Access Compliance Report

Public Rights-of-Way

Intersection ID: 47684	Main Street: NEWFIELD_ST	Cross Street: LEWISBURG_ST	Location: E
ADA ID: 089120967EF3	Ramp Type: BlendTrans1	Initial Pass/Fail: Fail	Overall Compliance: No
Severity Score: 8.75			
Codes/Mitigation Info/Possible Solution		Field Measurements/Component Compliance

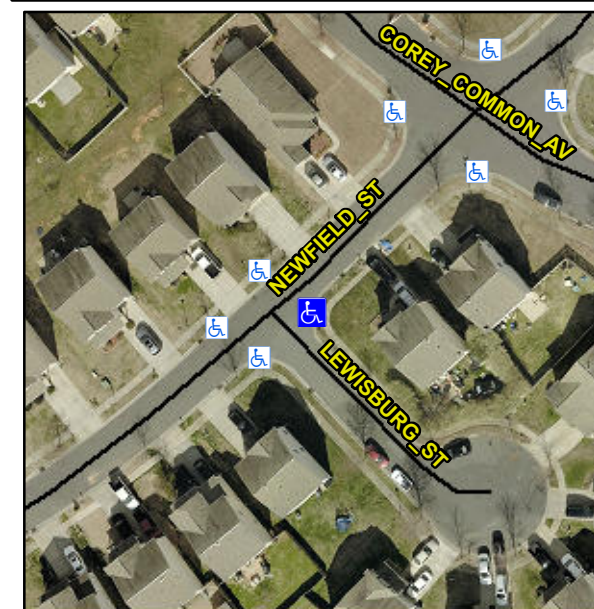
Compliance	Description	Data	Compliance	Description	Data
N/A	Ramp Length (in)	48.0	Yes	BlendTrans Slope (%)	2.1
No	Ramp Width (in)	47.5	Yes	BlendTrans XSlope (%)	0.7
N/A	Flare Type LT	N/A	N/A	Flare Type RT	N/A
N/A	Flare Slope LT (%)	N/A	N/A	Flare Slope RT (%)	N/A
N/A	Flare Traversable LT?	N/A	N/A	Flare Traversable RT?	N/A
N/A	Landing Length (in)	N/A	N/A	DWS Provided?	N/A
N/A	Landing Width (in)	N/A	N/A	DWS Contrast?	N/A
N/A	Landing Slope (%)	N/A	N/A	DWS Length (in)	N/A
N/A	Landing X Slope (%)	N/A	N/A	DWS Full Width?	N/A
N/A	Landing Curb? (Y/N)	N/A	N/A	DWS Offset (in)	N/A
N/A	Shared Landing?	N/A			
N/A	Gutter Ponding?	N/A	N/A	Gutter Slope (%)	N/A
N/A	Gutter Lip Ht (in)	N/A	N/A	Gutter X Slope (%)	N/A
N/A	Painted X Walk1?	No	N/A	Painted X Walk2?	No
	X Walk 1 Direction	To NW		X Walk 2 Direction	To SW
	X Walk 1 Width (in)	N/A		X Walk 2 Width (in)	N/A
	X Walk 1 Slope (%)	1.4		X Walk 2 Slope (%)	0.3
	X Walk 1 X Slope (%)	0.6		X Walk 2 X Slope (%)	1.1

Remove & Replace Curb Ramp With Two New Directional Ramps or Equivalent.

R304.5.1
